OFFICIAL STAR CLASS MEASUREMENT CERTIFICATE

Report from International Measurement Committee

Star No. 31189

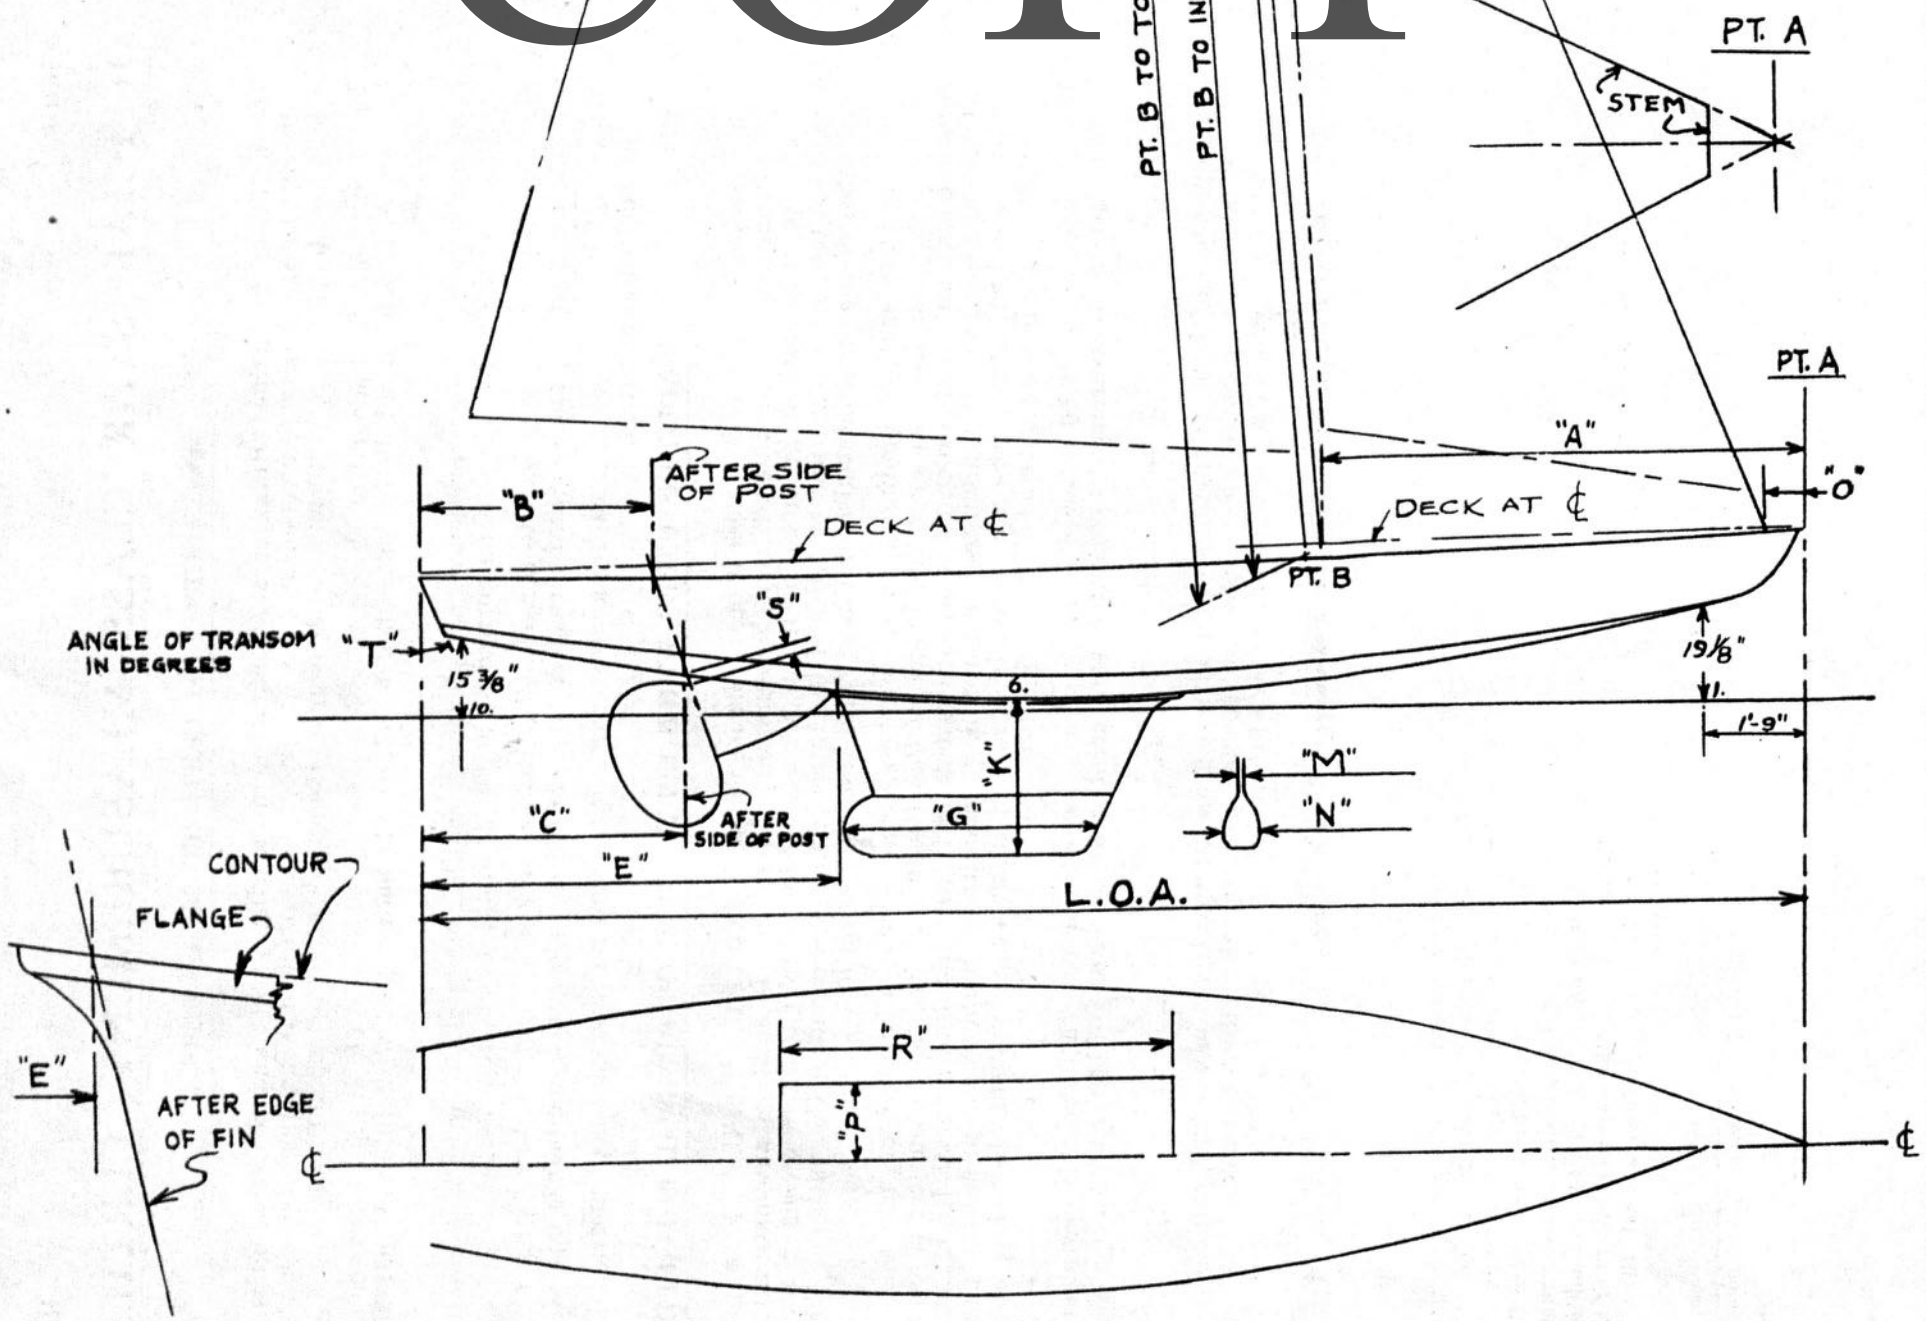
1. YACHT'S NUMBER? 3 1892. Was this number cut or burned into keelson as required above? yes3. Yacht's name "Pejerrey" 4. Year built 19515. By whom built? Fabrica Argentina de Aerodinamos6. Owner's Name Jorge A. Salas Chaves7. Address Avenida Quintana 475, Buenos Aires, Argentina8. Fleet OLIVOS 9. Remarks Heights of contour andchine at St. 6 are an approximation**CERTIFIED MEASURER'S AFFIDAVIT**

*Half Breadth Stern $\frac{1}{16}$ " under
"6" $\frac{7}{8}$ under*

- ☒ The points in question must be remeasured by a Certified Measurer and the results submitted to the Measurement Committee.
- ☐ The points in question must be altered to conform to the Specifications and then remeasured by a Certified Measurer and submitted to the Measurement Committee.

- 1) Enclosed is the heel weight certificate of the 1533,
Pollux.
St.No.6 contour is 2" 5/16 measured with aid of the
drainage hole
St.No.6 chine is 7" 9/16
The figures in the measurement certificate were marked
as approximation because there are fairings along the
keel, as indicated in the instructions to measurers.
- 2) I have remeasured the No. 3180, Dejerrey —
Half Breadth Stern is 19" 1/32
" " St.No.6 is 23" 15/16 ✓
- 3) In your last letter you inform me about the No. 3097
and 3189 but not about the No. 3138, Tramontane.
As all 3 certificates were sent in the same envelope,
I would appreciate your information.
